Pentium® II Xeon™ Processor Specification Update

Release Date: December 1998

Order Number: 243776-008

The Pentium® II Xeon™ processor may contain design defects or errors known as errata which may cause the product to deviate from published specifications. Current characterized errata are documented in this Specification Update.

D30. Thermal Sensor May Assert SMBALERT# Incorrectly

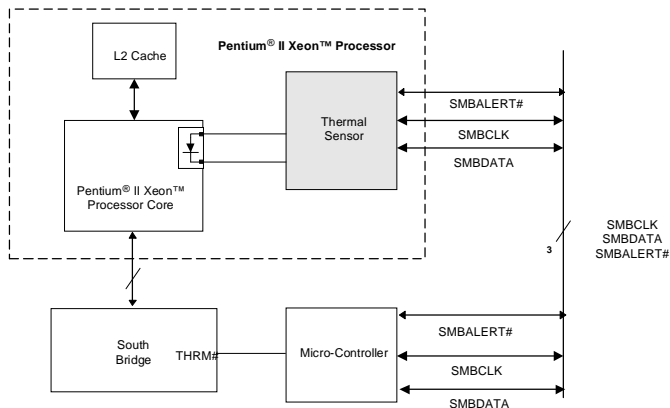
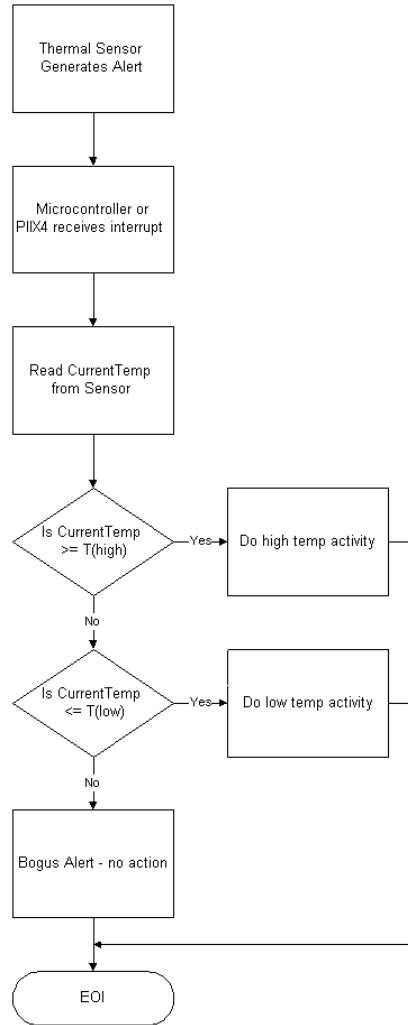
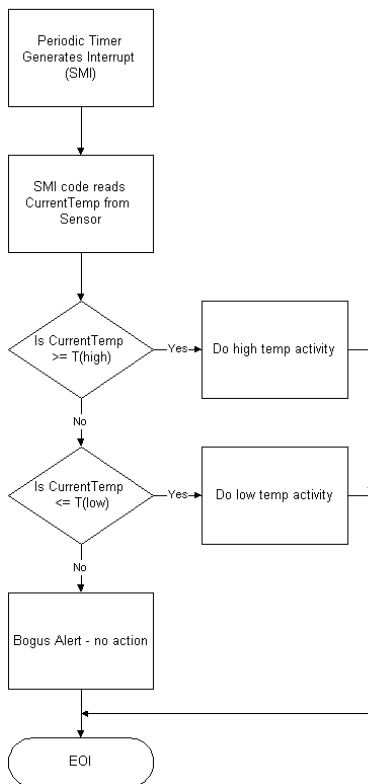
PROBLEM: The Pentium II Xeon processor has a thermal sensor that monitors the processor core's temperature. The thermal sensor asserts SMBALERT# if the processor temperature exceeds the temperature limits set in the Alarm Threshold Registers (T_{HIGH} , T_{LOW}). It also sets the corresponding Status Register bits to identify the cause of the interrupt. Figure 1 gives one example of the how the SMBALERT# signal could be used in a system.

Under the conditions described below, the thermal sensor incorrectly generates the SMBALERT# interrupt. *All* of the following conditions must be met to trigger a false interrupt:

WORKAROUND: Three different (mutually exclusive) workarounds are possible:

1. Before servicing an interrupt from the thermal sensor, read and compare the processor thermal reading with the threshold limits (T_{HIGH} or T_{LOW}). Figures 2 and 3 provide basic flowcharts for the implementation of this workaround in an interrupt driven system.
2. If the firmware implemented polls the Status Register only, then before taking any action, re-read the temperature register and do a comparison with the alarm threshold limits (T_{HIGH} or T_{LOW}) to determine if the value is actually still within the temperature window.
3. Use a temperature polling scheme to monitor the processor temperature.
